The technical bulletin board of SKANTI

Technical Information

- AP 9000 and CP 9000
- DSC 3000 and DSC 9000
- PC 9000
- SCANCOMM Telex
- SCANSAT-CG
- TRP 7000 Series
- TRP 8000 Series
- TRP 9500 Series
- VHF 3000
- Miscellaneous

SUBJECT: Compulsory key cover for the Alarm Panel Transmit key

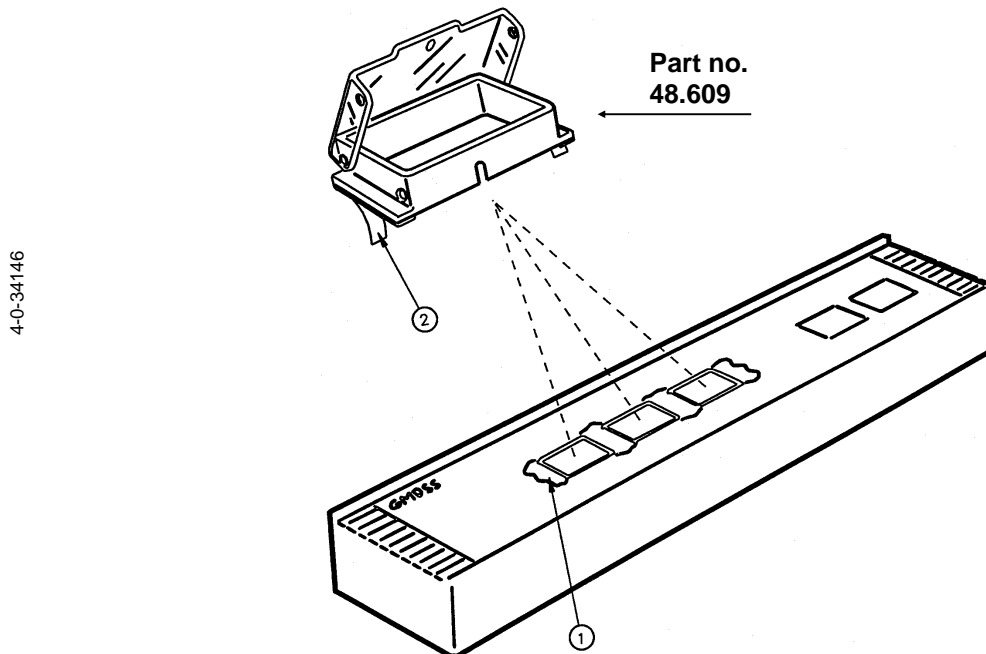
The IMO has revised the requirements on distress buttons in order to reduce the number of false alerts. The revised requirements which will be effective from the 23rd of November 1996, specify that the distress button should be protected against inadvertent operation and that distress alert initiation should require at least two independent actions. These requirements are specified in A.803(19) 2.7.2 and 2.8 for VHF, A.804(19) 2.6.2 and 2.7 for MF, A.806(19) 2.6.2 and 2.7 for MF/HF and A.807(19) 3.4.2 and 3.5 for INM-C.

To comply with these requirements SKANTI has introduced a key cover to fit over the transmit keys of the Alarm Panels.

1. Clean the two marked parts(1) of the keypad using isopropyl alcohol.
2. Remove the protective paper from the key cover(2).
3. Carefully align and fit the key cover over the transmit keys.

SUBJECT: COMBINED FACTORY RESETTING
PLUG FOR DSC/TELEX MODEM
PCP 717

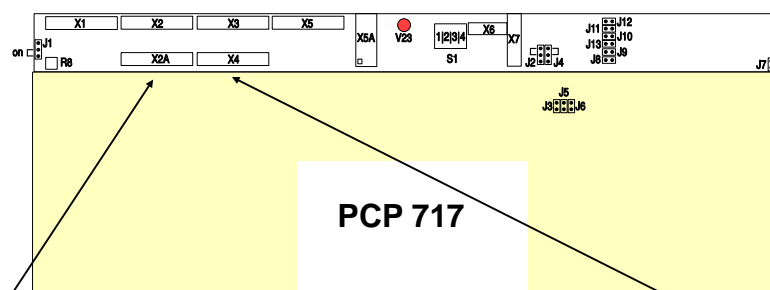
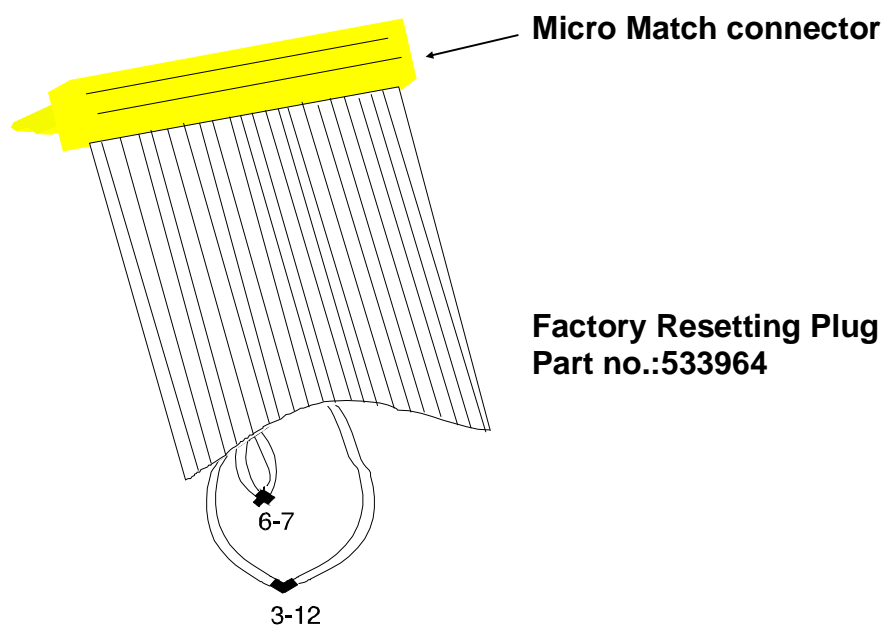
We are pleased to introduce a combined Factory Resetting Plug for the DSC/Telex modem PCP 717. This plug will Factory Reset a PCP 717 modem installed in one of the following products:

*Please note that the PCP 717 for the TRP 9500 is a combined DSC and Telex modem. Both DSC and Telex will be reset when a Factory Reset is performed.

X2A: Factory Reset in DSC 3000,
DSC 9000 or TRP 9500

X4: Factory Reset in TRP 7200

SUBJECT: Compulsory key cover for the
DSC Distress key

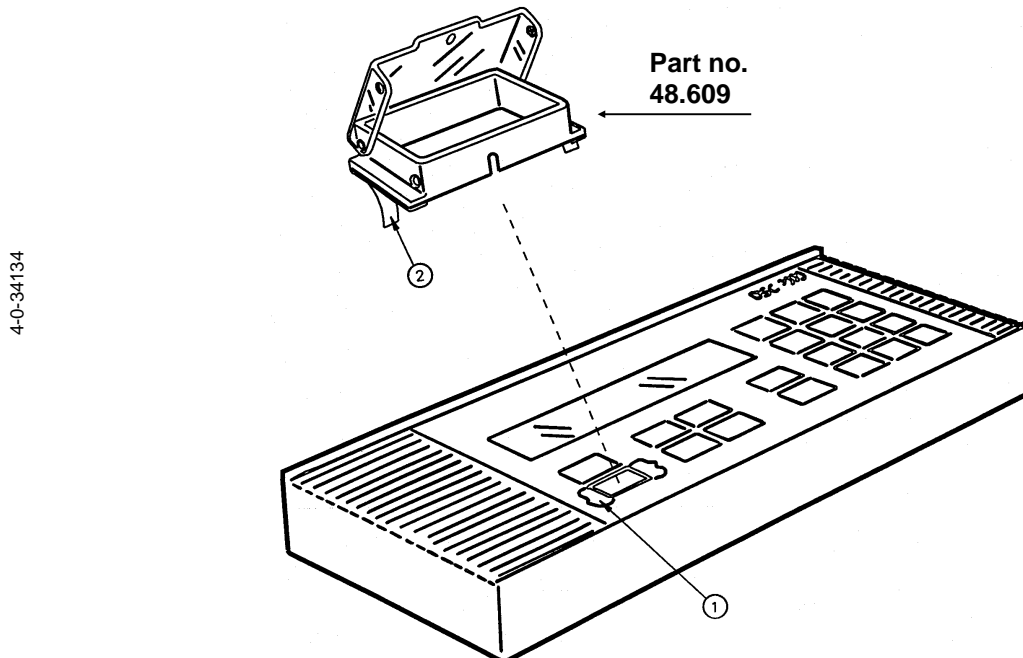
The IMO has revised the requirements on distress buttons in order to reduce the number of false alerts. The revised requirements which will be effective from the 23rd of November 1996, specify that the distress button should be protected against inadvertent operation and that distress alert initiation should require at least two independent actions. These requirements are specified in *A.803(19) 2.7.2 and 2.8* for VHF, *A.804(19) 2.6.2 and 2.7* for MF, *A.806(19) 2.6.2 and 2.7* for MF/HF and *A.807(19) 3.4.2 and 3.5* for INM-C.

To comply with these requirements SKANTI has introduced a key cover to fit over the distress key of the DSCs.

1. Clean the two marked parts(1) of the keypad using isopropyl alcohol.
2. Remove the protective paper from the key cover(2).
3. Carefully align and fit the key cover over the distress key.

Product: **DSC 3000 and DSC 9000****SUBJECT: DSC CONTROL UNIT SOFTWARE
EXCHANGE PROCEDURE**

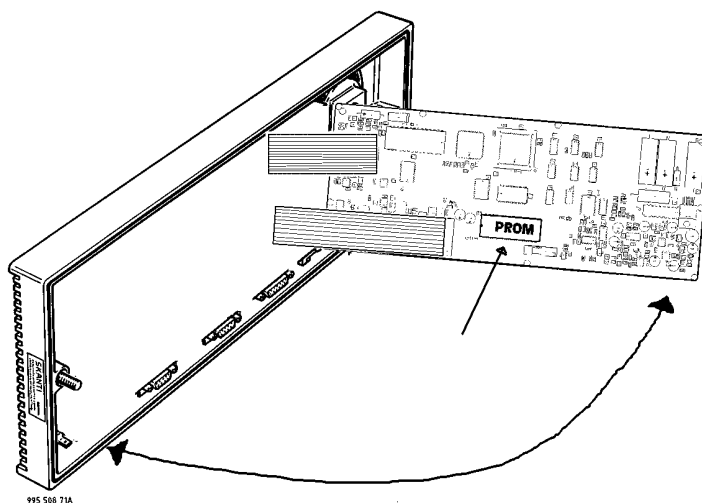
The procedure described below should be followed when exchanging the PROM of the DSC 3000 or DSC 9000 Control Unit for a new software version.

4. Swing out PCB 901 and locate the position of the PROM.

5. Carefully lift the PROM out of its socket using a small screwdriver.

6. Fit the new version PROM into the socket. Note that the marked end is pointing towards the ribbon cables - and that all pins go into the socket.

Fig.1

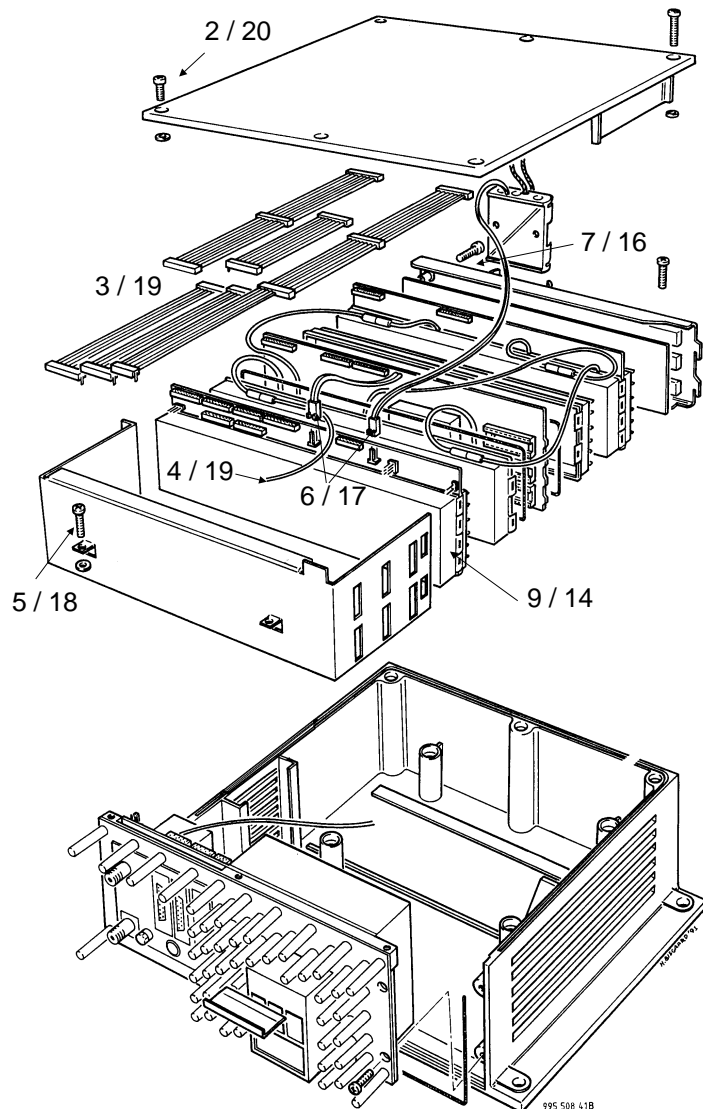
The procedure described below should be followed when exchanging the PROMs of the DSC 9000 for a new software version.

2. Remove the six screws from the top cover of DSC Unit DU 9000 and remove the top cover.

3. Disconnect the ribbon cables from the 3-module board assembly, carefully noting their position.

4. Disconnect the coaxial cable from the board assembly noting its position.

5. Loosen the four screws on the board assembly and pull the board assembly out from the DU cabinet.

Fig.2

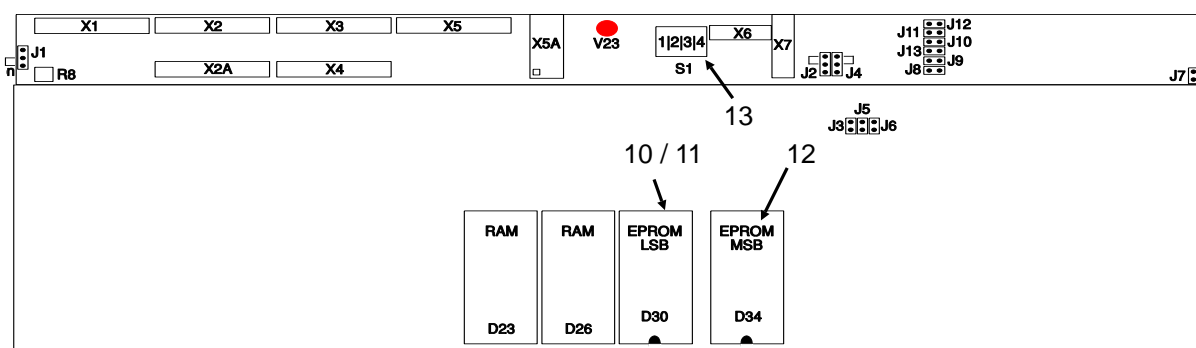
10. Locate the LSB/EVN PROM on PCB 717 (fig.2) and carefully lift it out of its socket using a small screwdriver.

11. Fit the new version LSB/EVN PROM into the socket. Note that the marked end is pointing toward the PCB edge - and that all pins go into the socket.

12. Steps 10 and 11 are now repeated with the MSB/ODD PROM.

13. All 4 dip switches on S1 are set to position off.

Fig.1

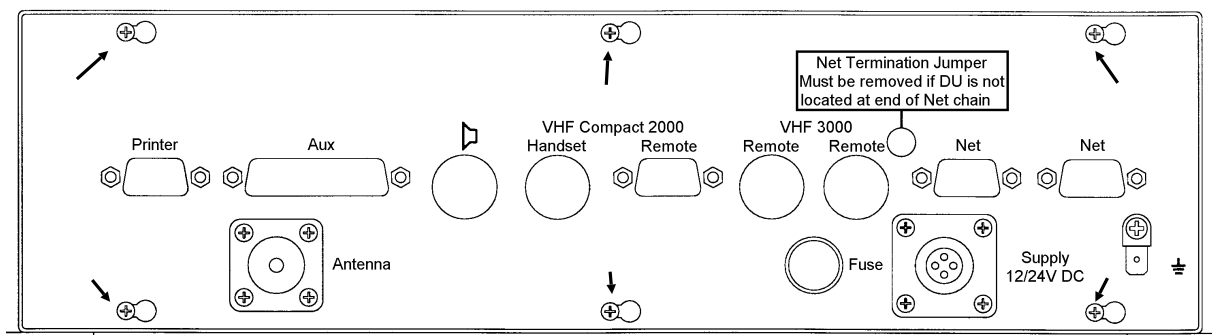
1. Switch the DSC 3000 off.
2. Loosen the 6 screws of the connector panel (fig.1) and carefully take the board assembly out of the cabinet.

Fig.2

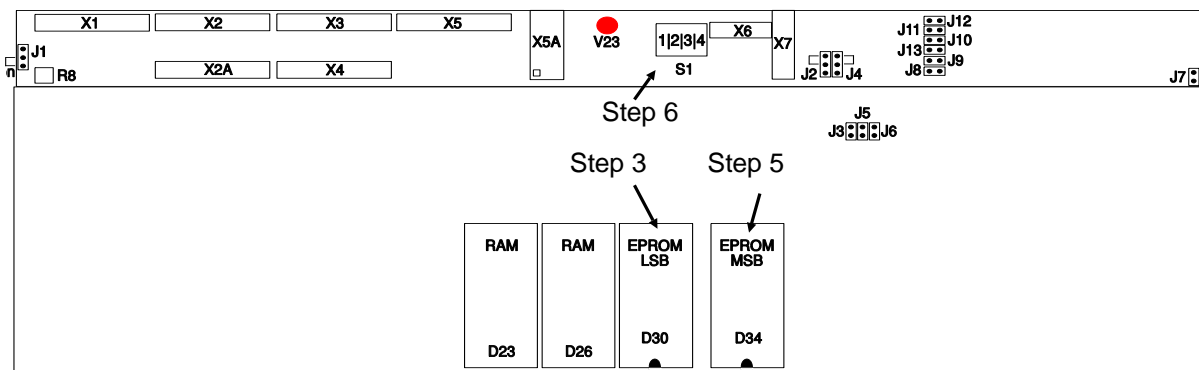
3. Locate the LSB/EVN PROM on PCB 717 (fig.2) and carefully lift it out of its socket using a small screwdriver.

4. Fit the new version LSB/EVN PROM into the socket. Note that the marked end is pointing towards the PCB edge - and that all pins go into the socket.

5. Steps 3 and 4 are repeated with the MSB/ODD PROM.

6. Check that all 4 dip switches on S1 (fig.2) are set to position off.

SUBJECT: ATU 7200 COIL WIRE PROBLEM

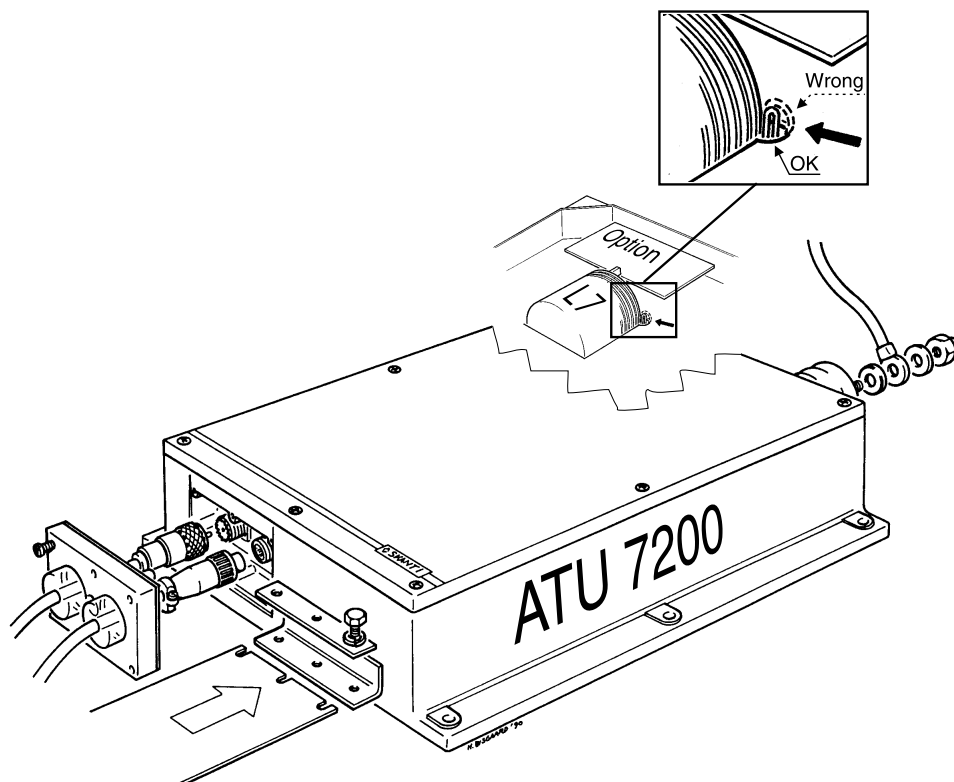
Due to a mistake in our production a coil of the Antenna Tuning Unit 7200 was not fitted properly in a number of ATU boards 740.

The problem is the bending of the L7 coil wire where routed to the bottom side of the board. If the wire bending is not sufficiently sharp (indicated on fig. by dashed lines), it may cause sparks inside the ATU.

The problem is solved by carefully making a more sharp bend on the wire (filled lines on fig.) leaving space between the wire and the board.

SUBJECT: FACTORY RESETTING OF TELEX MODEM 717 INSTALLED IN TRP 7200

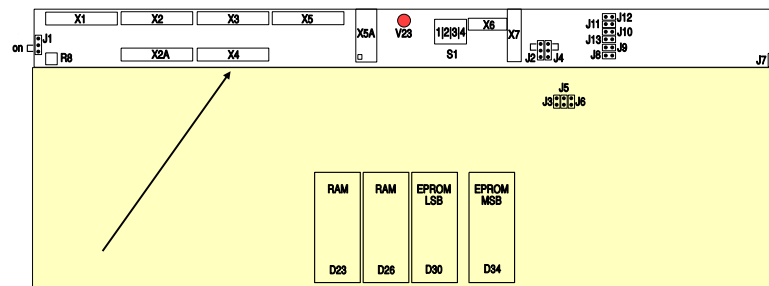
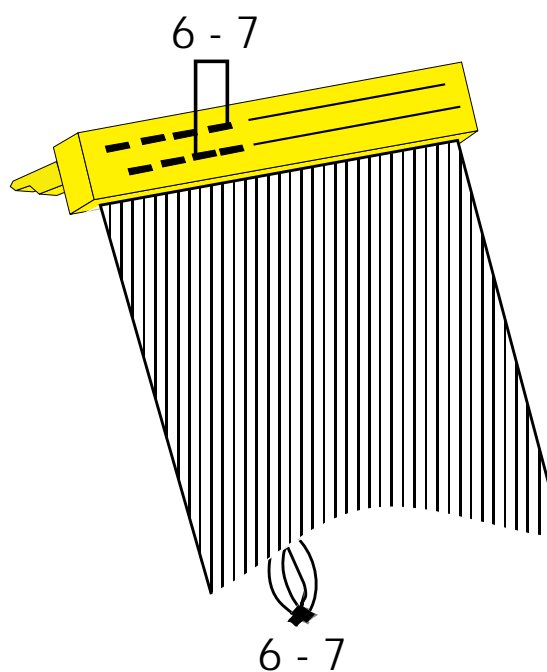
Technical Information no. 00965095 was issued on this subject, but due to the fact that 'Telex Alarm' output lines now have been implemented in the TRP 7200 occupying the 'Com' connector pins 4 and 18 which formerly were used for the 'Factory Resetting' - this new procedure for 'Factory Resetting' of TRP 7200 with Telex modem PCP 717 is issued.

1. Switch equipment on and disconnect the supply voltage.
2. Remove the Transceiver Unit 7200 top cover.
3. Disconnect the ribbon cable connecting the PCBs 730 and 717.
4. Insert the 'Micro-MaTch' Factory Resetting plug (description enclosed) in the 20 way 'Micro-MaTch' socket X4 of PCB 717.

Fit a piece of 20-wire ribbon cable into a 20 way 'Male-on-wire Micro-MaTch' connector.

Connect the ends of the 2 wires 6 and 7 and isolate the connection.

Or just fit a single wire between connectors 6 and 7.

SUBJECT: ATU 8000
Cabinet improvements

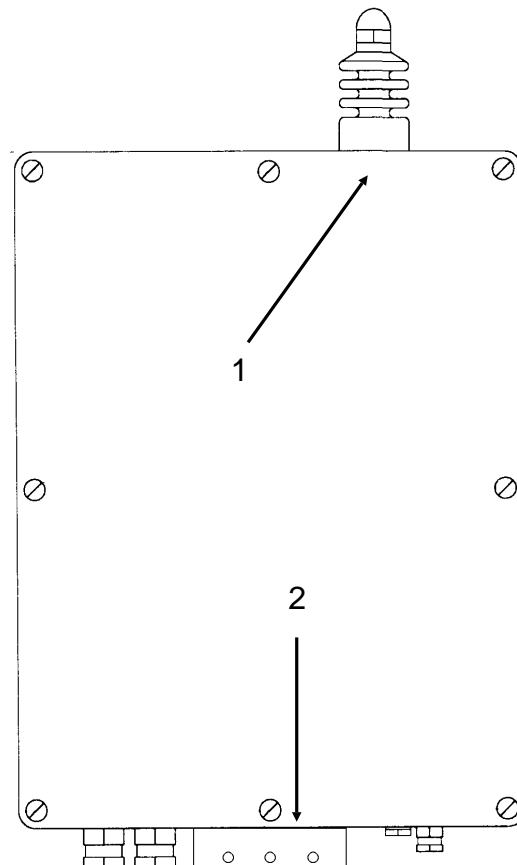
The cabinet of the Antenna Tuning Unit of the TRP 8000 series has been modified. The purpose of the modifications is to improve the watertightness of the cabinet.

The above modifications are implemented in the Antenna Tuning Unit 8000 from serial number 31126.

SUBJECT: CU 8000
Control Board Replacement

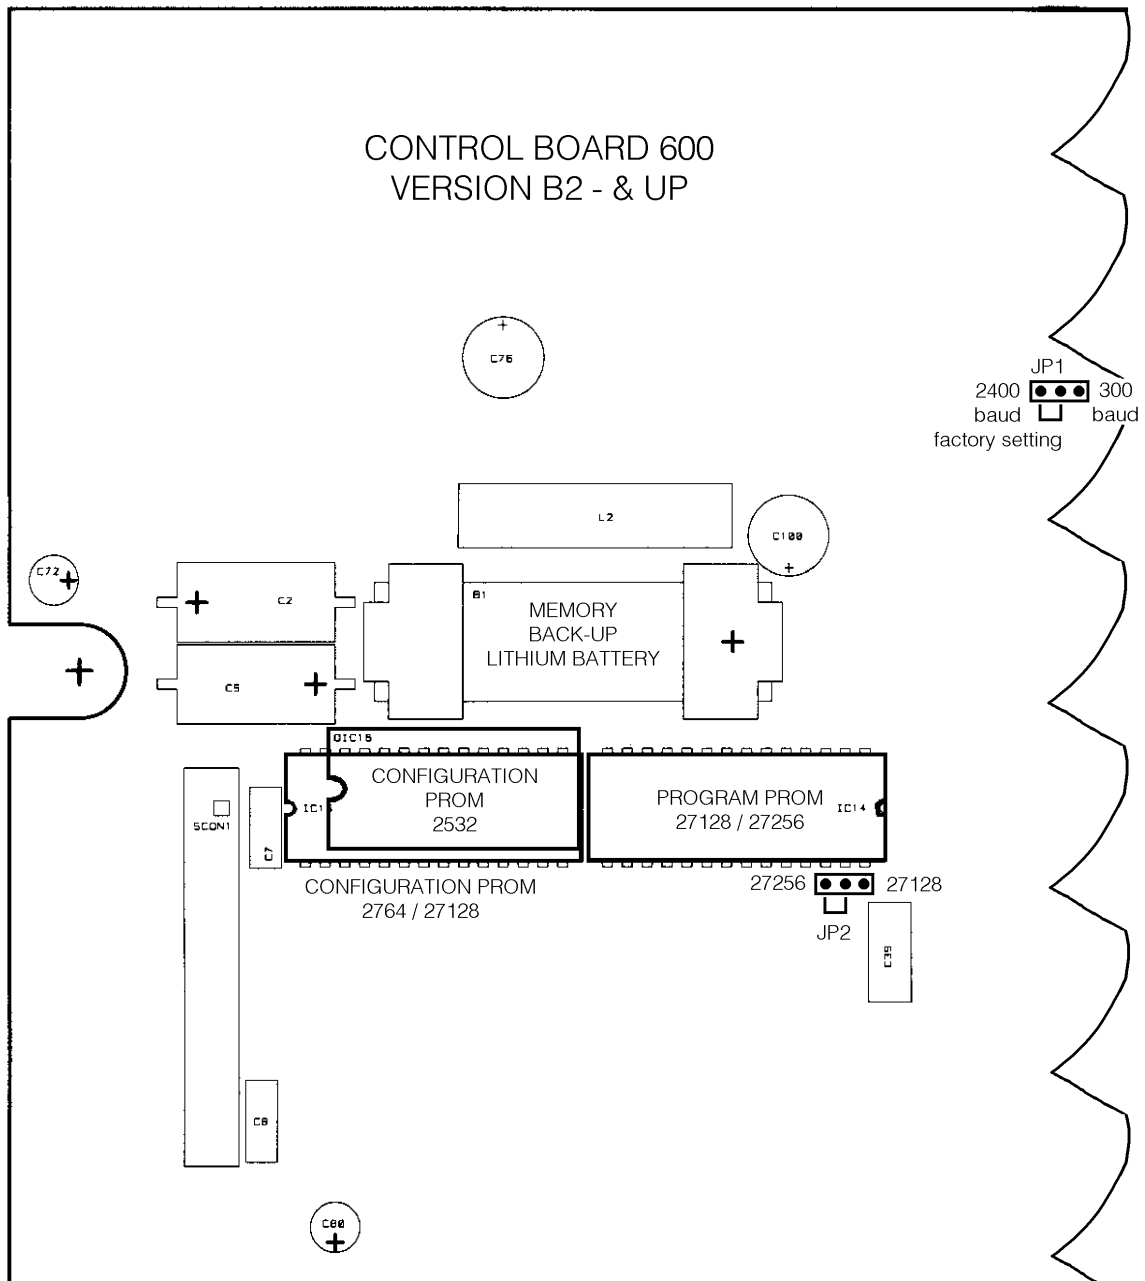
The Control Board 600 of the Control Unit 8000 has been revised. The main reason was to widen the applicable range of E-Prom types used on Control Board 600.

* The **Program Prom** (type 27128) of the defective Control Board may alternatively replace the Program Prom (type 27256) fitted on the new Control Board and the selection link/jumper JP2 for Program Prom type is set to the 27128 position connecting the free pin to the center pin. Please refer to the figure of the Control Board on the next page.

Compatible Program Prom types are 27128 or 27256. Selection link/jumper JP2 for Program Prom type must be set accordingly.

Subject: NEW TRP 8000 SERIES STANDARD KEYBOARD

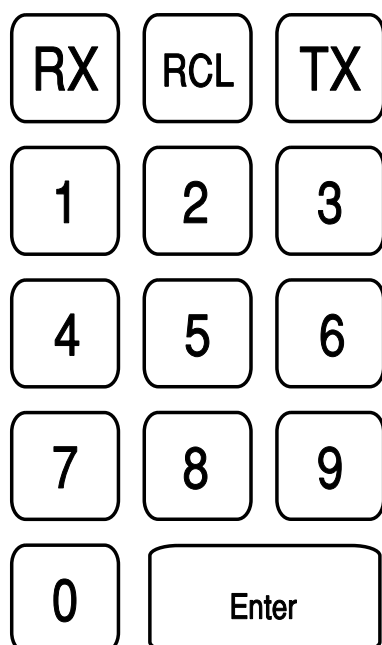
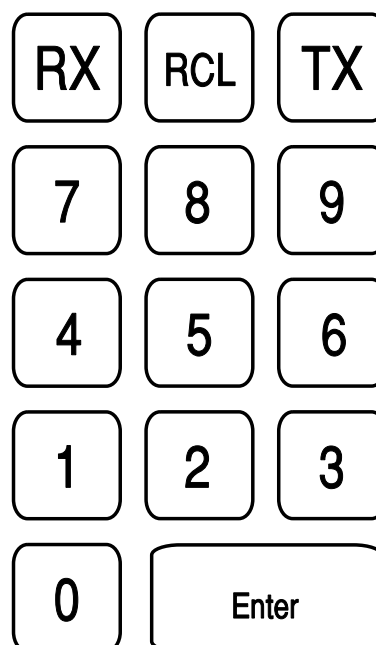
In connection with our new design of CU 8000 (updated front and colour) we have a different location of the numbers on the Control Unit Numeric Keyboard (Membrane Overlay)
